Subject: N242485170 - Service Update
Terminating Resistor Missing

Models: 2025 Buick Enclave

N242485170 Terminating Resistor Missing

Condition	Certain vehicles listed above may have a condition where the terminating resistor is missing for specific circuits.
Correction	Dealers are to rework the lighting control module connector.

6766791

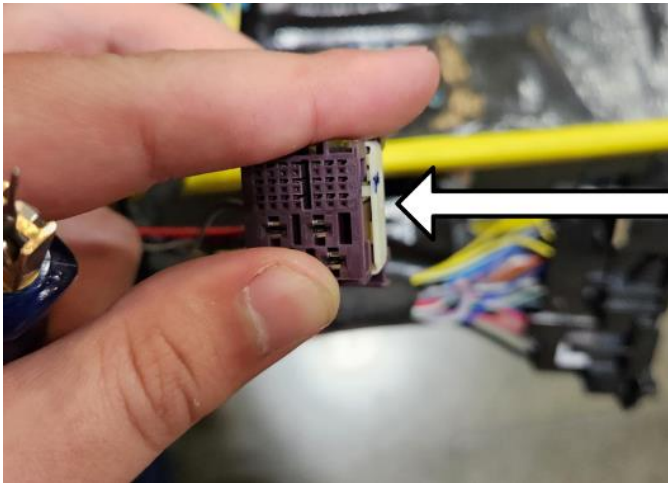
3. Access the Lighting Control Module underneath the instrument panel and remove it from its mounting bracket.

4. Remove the Dark Purple X4 Connector by disengaging the CPA and pushing down on the push pin.

6766804

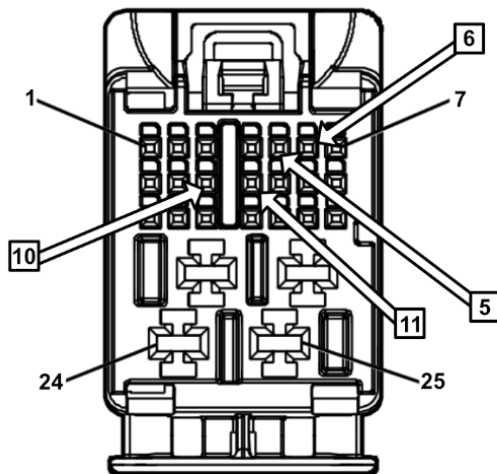
Important: DO NOT FULLY REMOVE THE WHITE TPA TAB. DOING SO WILL BREAK THE TPA.

- Using a small screwdriver, unlock the TPA by partially prying out the white tab on the side of the connector.

6766805

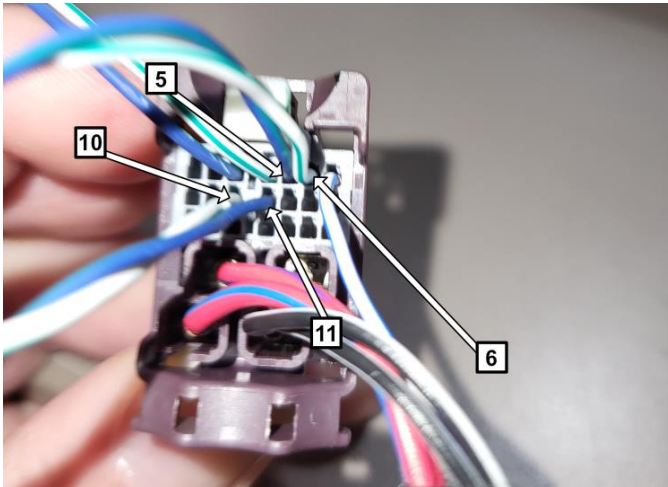
Important: Remove only terminals 5 and 6 from the connector. No other terminal should be removed from the original wires.

- Using the GM-38125-58 Terminal Removal Tool at the service openings on the front of the connector face, remove the white with green wire terminal from cavity 6.
- Using the GM-38125-58 Terminal Removal Tool at the service openings on the front of the connector face, remove the blue wire terminal from cavity 5.
- Cut off the terminal ends off both wires and individually wrap each wire end in electrical tape. Tape both wires back into the main branch.

6766806

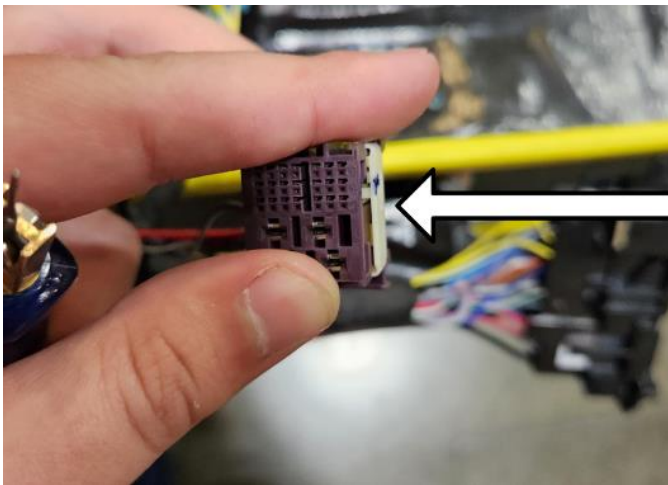
9. Using the provided Twisted Pair Jumper, seat the white with green wire terminals in cavities 5 and 11.
10. Using the provided Twisted Pair Jumper, seat the blue wire terminals in cavities 6 and 10.
